# Global MX-5 Cup Car Technical Service Bulletin #06-27-2017

### **<u>REQUIRED</u>**: 2017 Global MX-5 Update: **Cooling hose clamp** update effective immediately

#### **Diagram:**

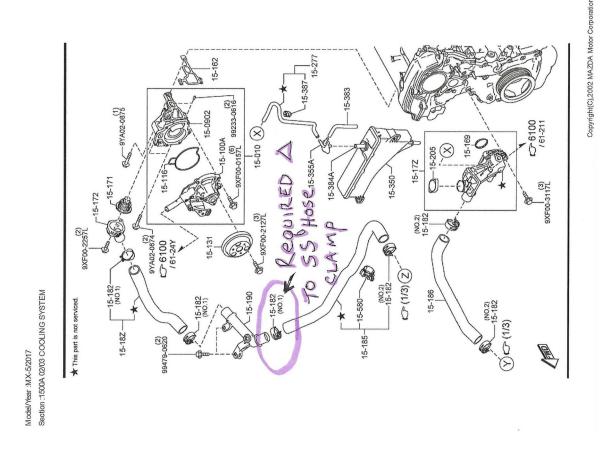
1. A chance of the lower radiator hose clamp may become dislodged (see diagram). The factory spring style clamp is being replaced with a standard stainless steel screw style clamp. This ONE clamp is a mandatory change, but all other water hose clamps may be changed to a stainless steel screw style clamps at your option. Purchase the clamp(s) locally.

1. Follow all Mazda service manual instructions for safety, removal and replacement of the water hose clamp(s).
